Docket No. 52-021
MHI Ref: UAP-HF-08141

Subject: MHI's Response to NRC's Request for Additional Information on US-APWR Topical Report MUAP-07010-P, Non-LOCA Methodology

MHI's Response to NRC's Request for Additional Information on
US-APWR Topical Report MUAP-07010-P, Non-LOCA Methodology

**Figure 2.1-3.16 Steam Generator Water Mass versus Time
 Feedwater System Pipe Break**

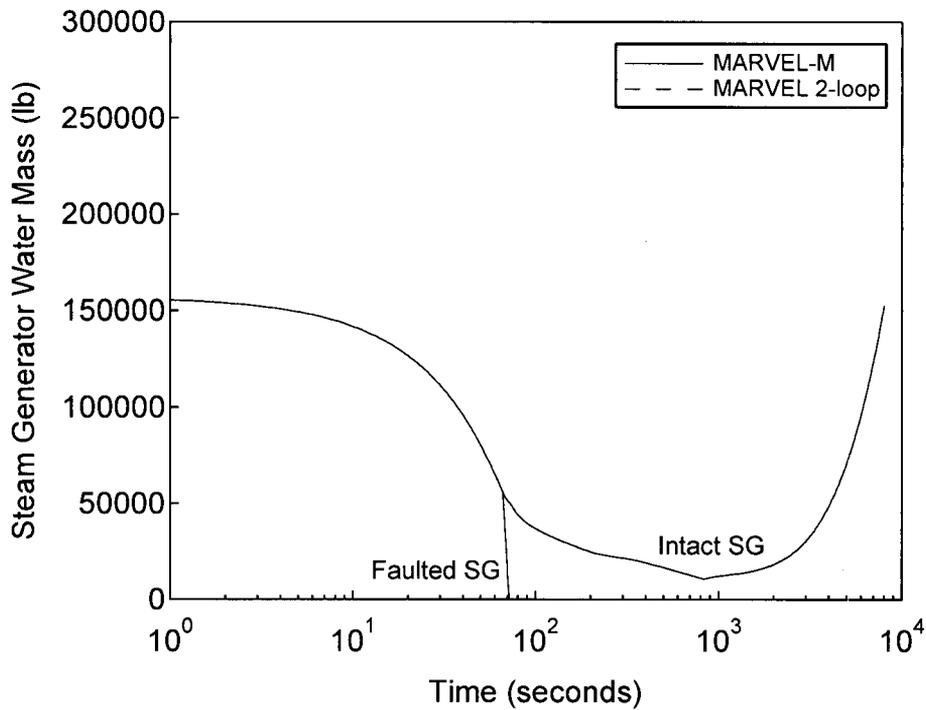
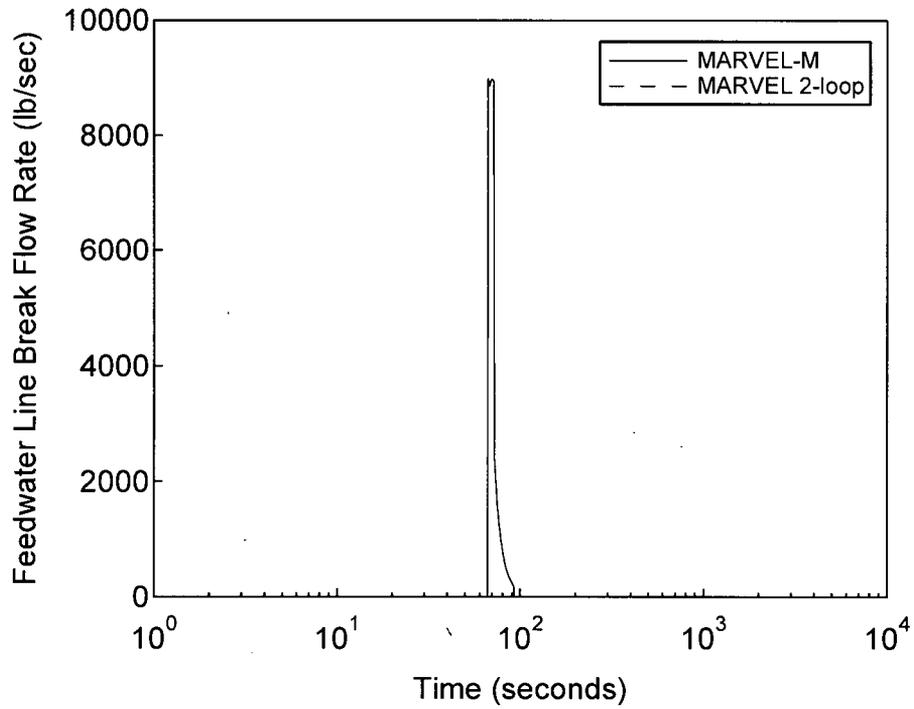
Have any MARVEL/MARVEL-M code comparisons been performed? Please provide a MARVEL/MARVEL-M code comparison for a typical 2-loop calculation.

Comparisons between the MARVEL and MARVEL-M codes have been performed for non-LOCA events as a verification of the extension from a 2-loop simulation to a 4-loop simulation. The results of these comparisons are introduced in the following figures. Figures 2.1-3.1 through 2.1-3.6 show the comparison of "Loss of Load" as a uniform event and Figures 2.1-3.7 through 2.1-3.17 show the comparison of "Feedwater System Pipe Break" as a non-uniform event. The 4-loop MARVEL-M case is set up to assume the break in a single loop with all of the remaining loops receiving the same emergency feedwater flow. This allows a direct comparison with 2-loop MARVEL, which models these loops as a single loop. Both the 2-loop MARVEL and 4-loop MARVEL-M runs utilize the hyperbolic coast down reactor coolant pump model, again allowing for direct comparison of the code output.

The results demonstrate nearly exact agreement between the 2-loop and 4-loop codes for both primary and secondary parameters of interest.

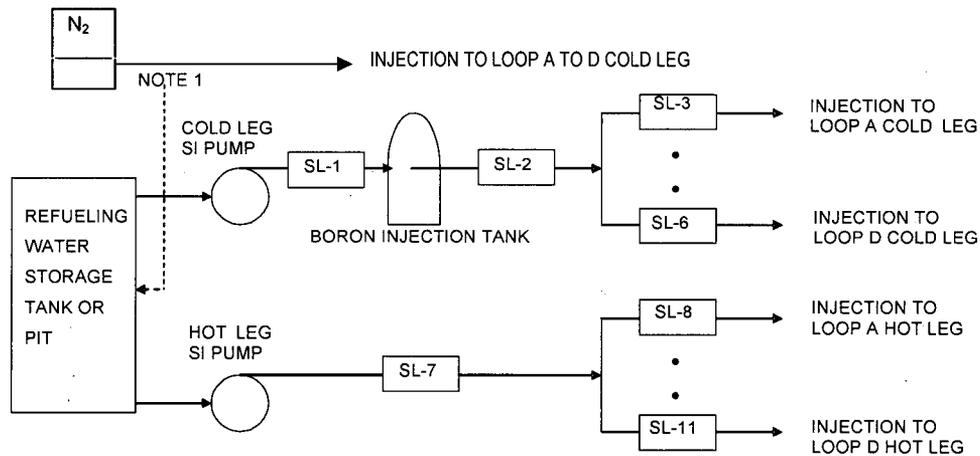
Please provide the details of cold leg injection by the safety injection system and its role in non-LOCA events.

As shown in the schematic drawing below from the MARVEL-M code manual, MARVEL-M has the capability to model several different safety injection system configurations. The upper flow path shown on the figure below models one SI pump, a common discharge header, and flow split to the four cold legs. This flow path model includes a Boron Injection Tank consistent with earlier plant designs. For newer plant designs such as the US-APWR that do not have a boron injection tank, this volume can be set to zero. Because for non-LOCA accidents the reactor coolant (RCS) pressure is the same at the cold leg inlets, one or more trains of SI pumps can be modeled with a single pump, as shown in the figure.

The lower flow path shown on the figure models a second single SI pump, a common discharge header, and flow split to the four hot legs. The user can select the injection point as the hot legs, the deluge line, or the reactor vessel downcomer.

Figure 2.1-17.1 Loss of Non-Emergency AC Power to the Station Auxiliaries Comparison between LOFTRAN and MARVEL-M (1)

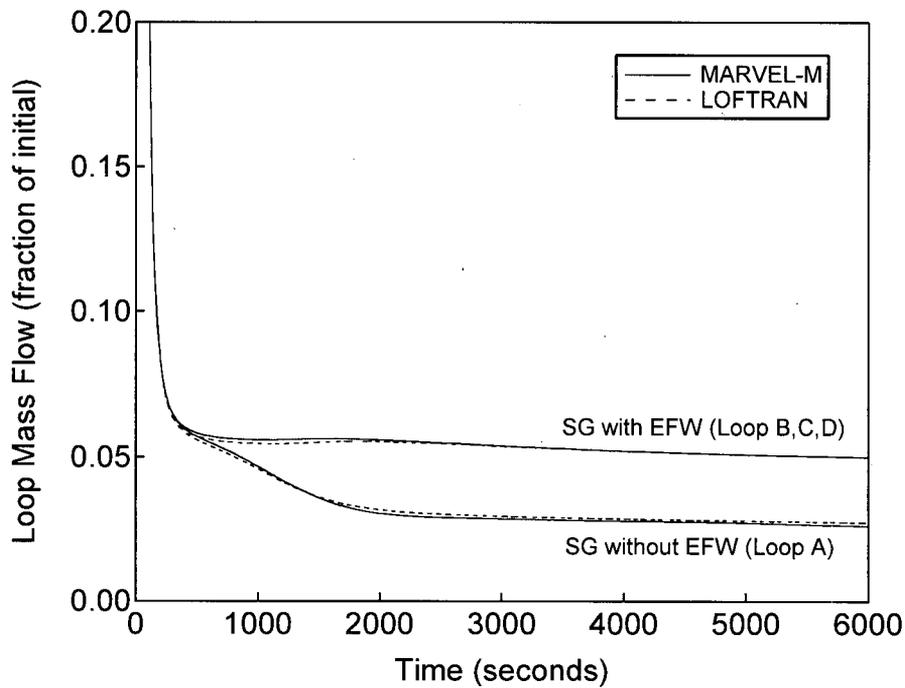
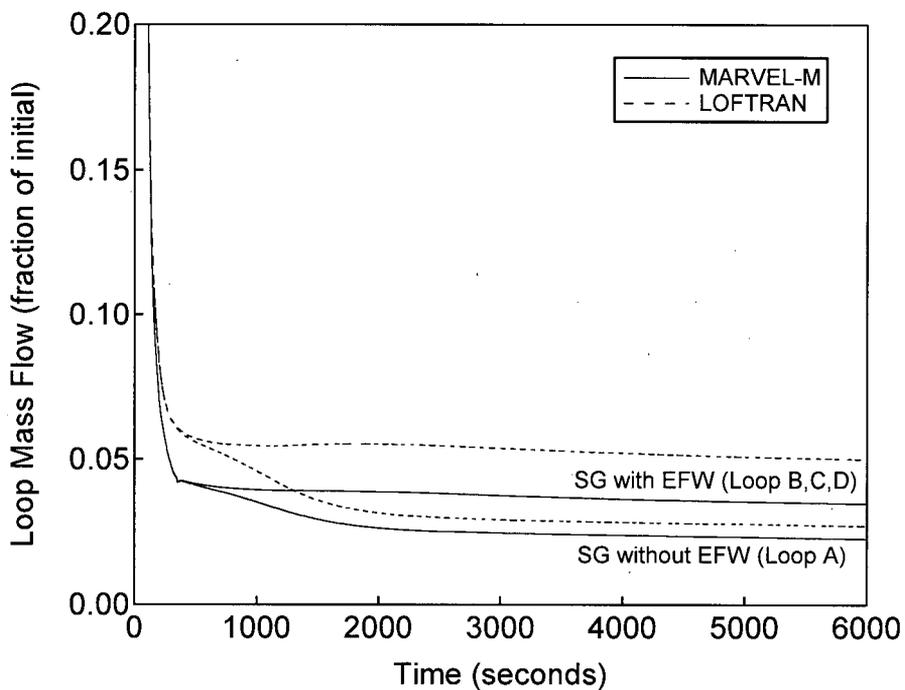
Transition to natural circulation flow is modeled in MARVEL-M and the elevation head equations are typical. Has this model been tested against scaled experimental data? If so, please provide comparisons.

The MARVEL-M transient flow model has not been compared to scaled experimental data. However, the MARVEL-M model has been compared with LOFTRAN (in a manner similar to the code comparisons provided in MUAP-07010 Section 3) in order to verify the natural circulation model.

Figure 2.1-17.1 shows the loop mass flow rate comparison between MARVEL-M and LOFTRAN for the "Loss of Non-Emergency AC Power to the Station Auxiliaries" event. The natural circulation flow of both the loop without emergency feedwater (EFW) and the loops with EFW after the reactor coolant pump (RCP) coastdown have very good agreement.

Figure 2.2-1.1 Flowchart of the Discontinuity Factor Process

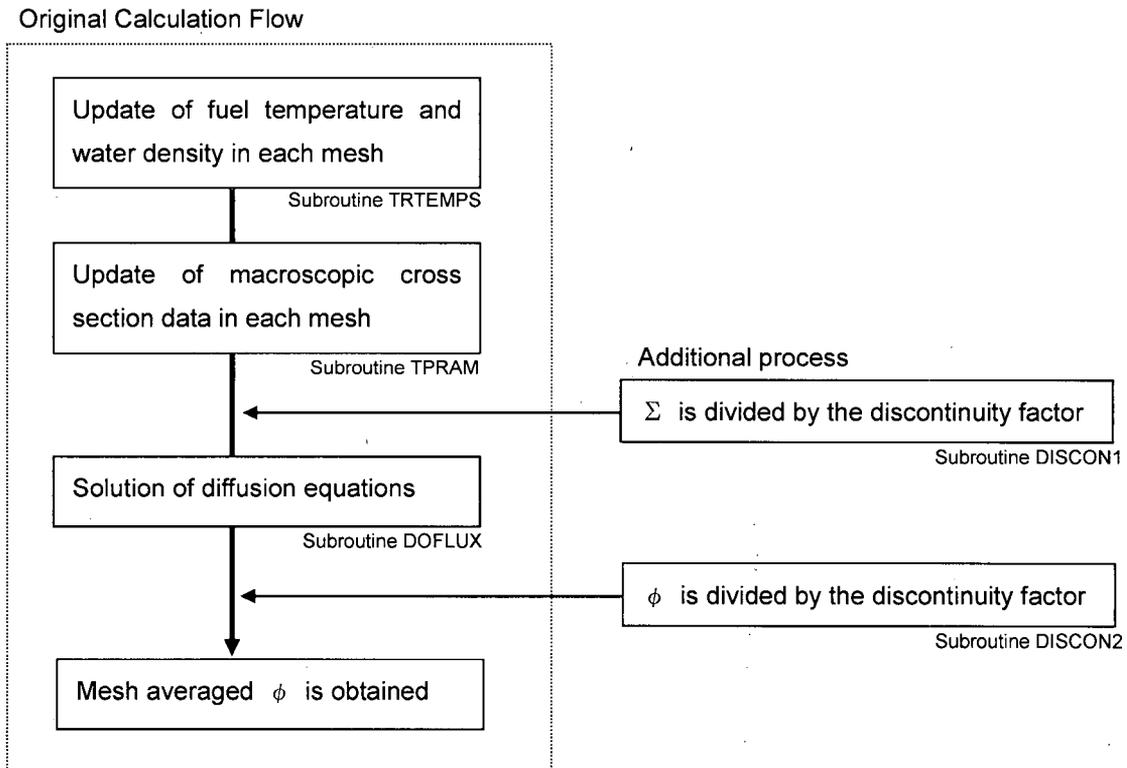
There are several differences between TWINKLE and TWINKLE-M that are mentioned but not discussed in any detail. The introduction of more spatial points and discontinuity factors suggests that the numerical algorithm for solving the diffusion equations may have also been changed although it is not stated. Please list all changes and provide additional description of the differences between the codes.

A discontinuity factor was added as a new input process in the program. The purpose of the discontinuity factor is to improve the representation of the local power distribution in the three-dimensional calculations. The addition of the discontinuity factor does not change the diffusion equations in TWINKLE. Instead, the discontinuity factor implementation is shown in Figure 2.2-1.1 and described as follows:

- The macroscopic cross section data is divided by the discontinuity factor before solving the diffusion equations (additional process).
- The neutron flux is solved using the unchanged TWINKLE diffusion equation subroutine.
- The neutron flux is divided by the discontinuity factor to determine the mesh averaged neutron flux (additional process).

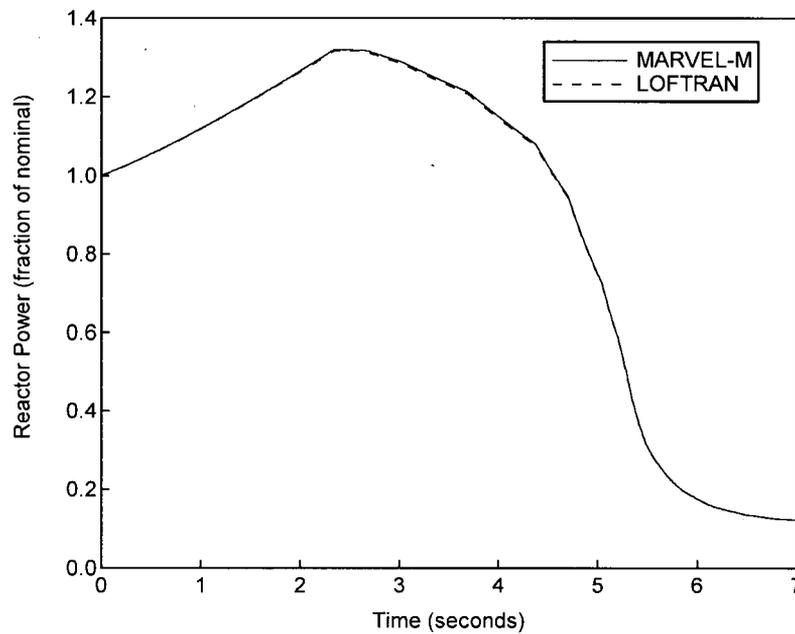
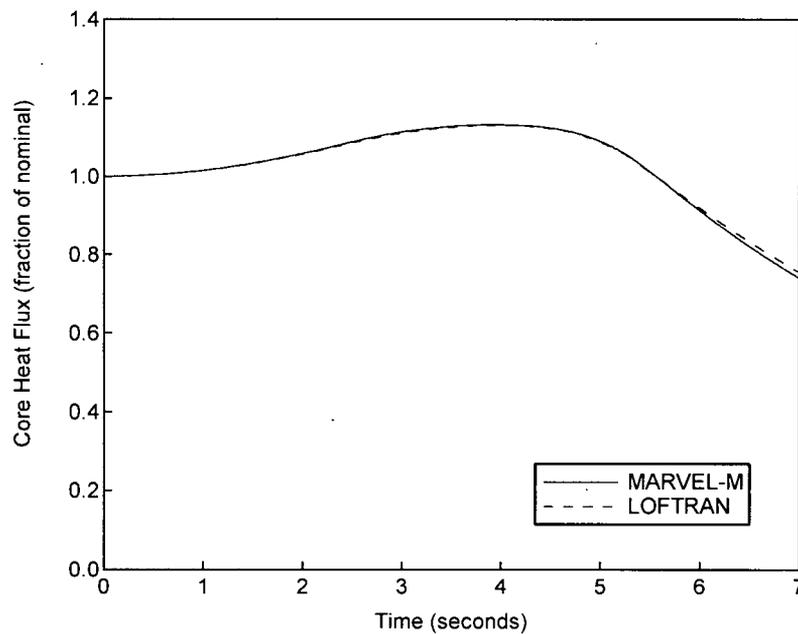
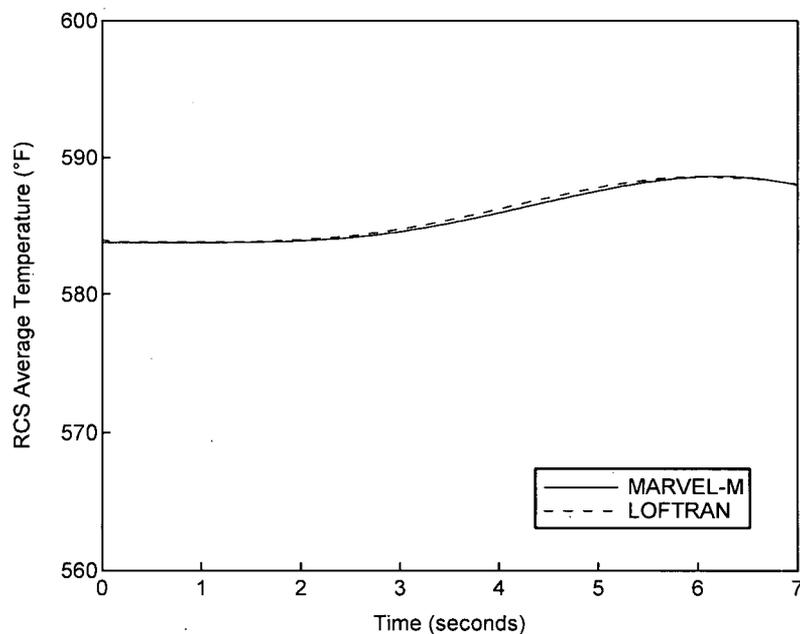
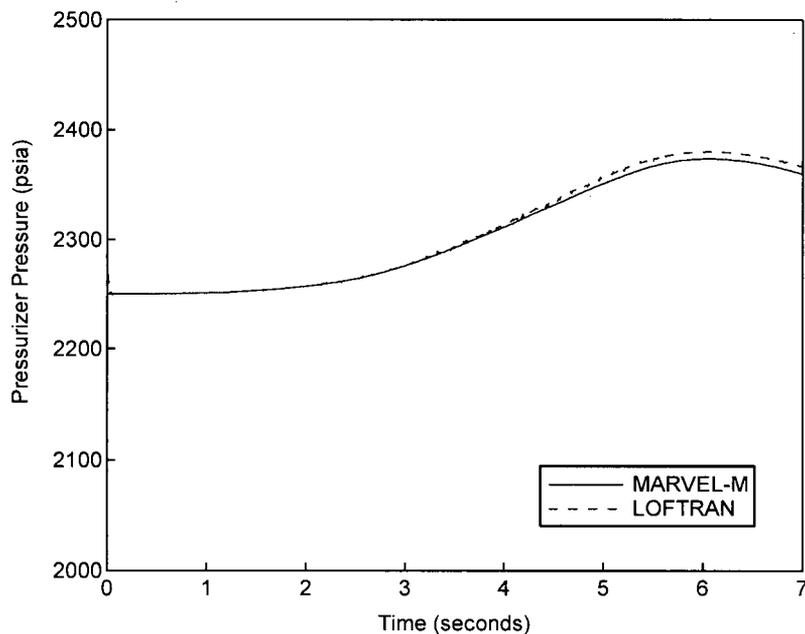
Please provide documentation of MARVEL-M/LOFTRAN code comparisons that may not be in agreement (if available), along with any explanations for the deviations.

Figures 3.1-2.1 through 3.1-2.4 show the comparison between MARVEL-M and LOFTRAN for the case where the pressure control system is available assuming the pressurizer spray is actuated by the actual pressurizer pressure signal. The LOFTRAN predicted RCS pressure is slightly higher than the MARVEL-M code prediction due to the previously described spray model differences. Because the differences occur below the safety valve pressure, differences in the safety valve models have been ruled out as the cause for the differences. In addition, as stated above, the transient comparison without pressurizer pressure control is virtually identical. The other transient parameters have good agreement between the two codes.

Figure 3.1-3.1 DNBR versus Time

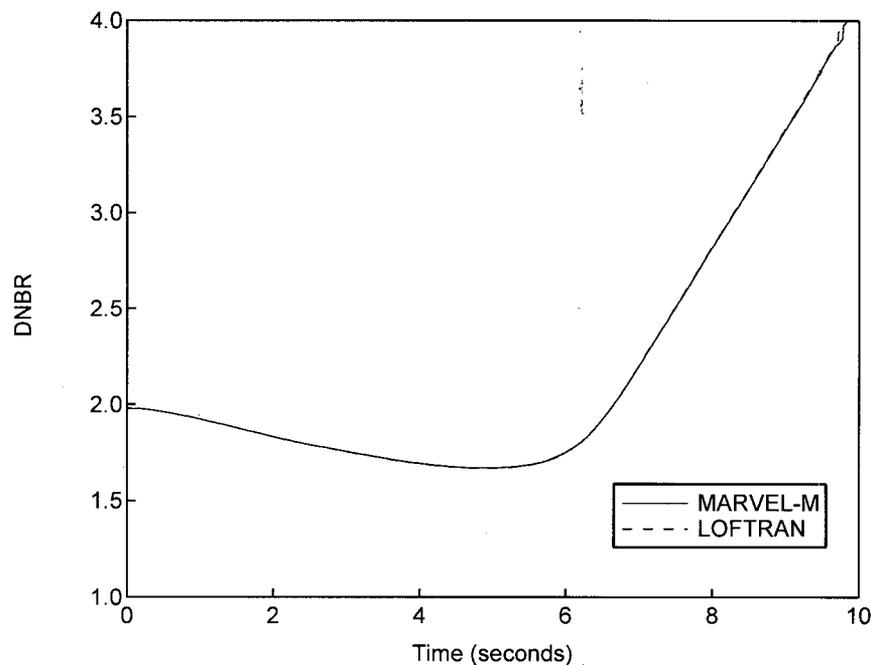
Please provide the DNBR vs. t for the partial loss of forced reactor coolant flow analyses for both MARVEL-M and LOFTRAN.

As a clarification, DNBR is calculated by the VIPRE-01M code for this event using power and flow calculated by either MARVEL-M or LOFTRAN. The figure below provides a comparison of the DNBR for the partial loss of forced reactor coolant flow event. The two codes provide identical DNBR results for this event.

Figure 3.1-4.1 DNBR versus Time

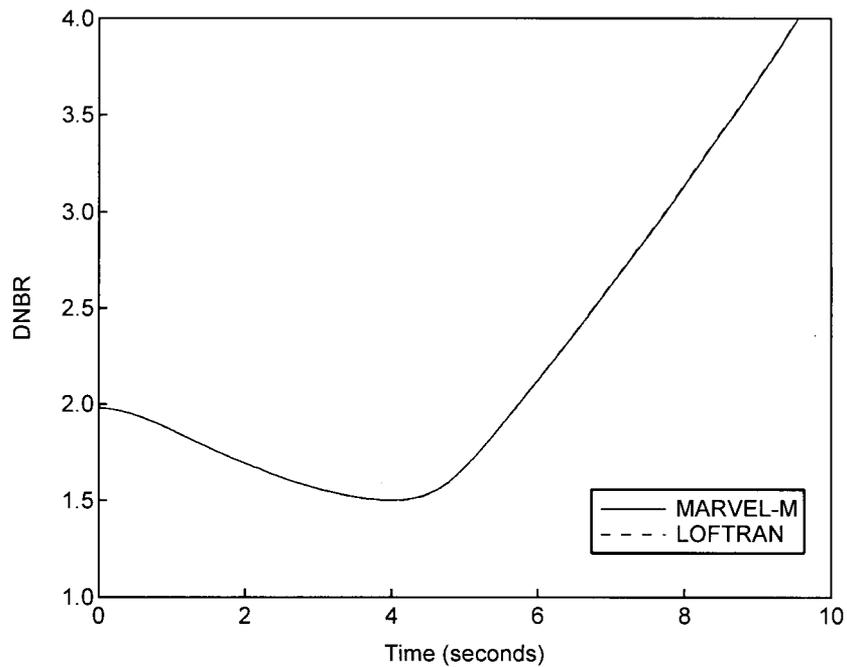
Please provide the DNBR vs. t for the complete loss of forced reactor coolant flow analyses for both MARVEL-M and LOFTRAN.

As a clarification, DNBR is calculated by the VIPRE-01M code for this event using power and flow calculated by either MARVEL-M or LOFTRAN. The figure below provides a comparison of the DNBR for the complete loss of forced reactor coolant flow event. The two codes provide identical results for this event.

Figure 3.1-5.1 **DNBR versus Time**
Reactor Coolant Pump Shaft Seizure
Comparison between MARVEL-M and LOFTRAN

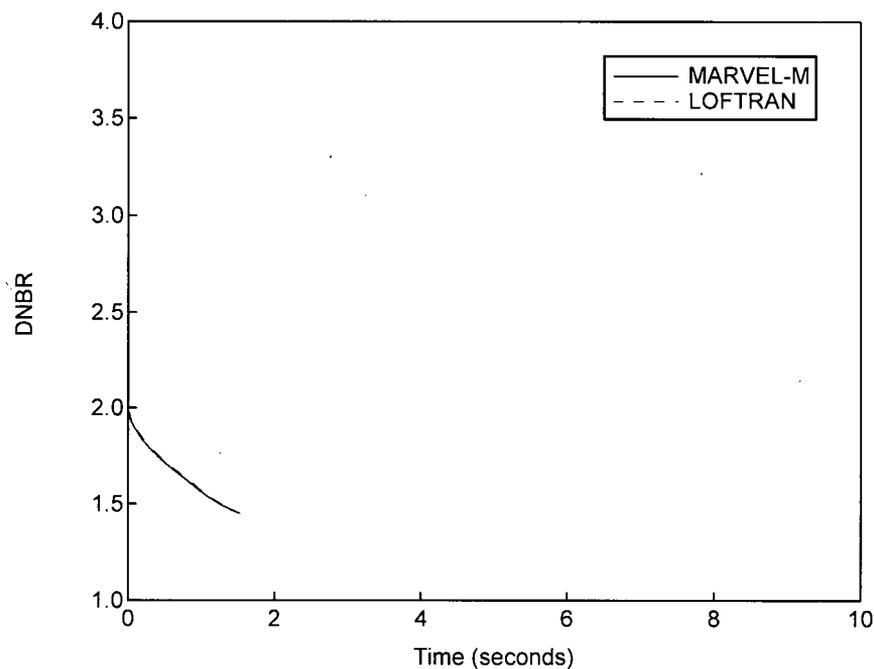
Please provide the DNBR vs. t for the partial reactor coolant pump shaft seizure analyses for both MARVEL-M and LOFTRAN.

As a clarification, DNBR is calculated by the VIPRE-01M code for this event using power and flow calculated by either MARVEL-M or LOFTRAN. The figure below provides a comparison of the DNBR results for reactor coolant pump shaft seizure event.

Note that the figure only shows the DNBR transient until the DNBR reaches its safety analysis limit. The two codes show identical results for this transient.
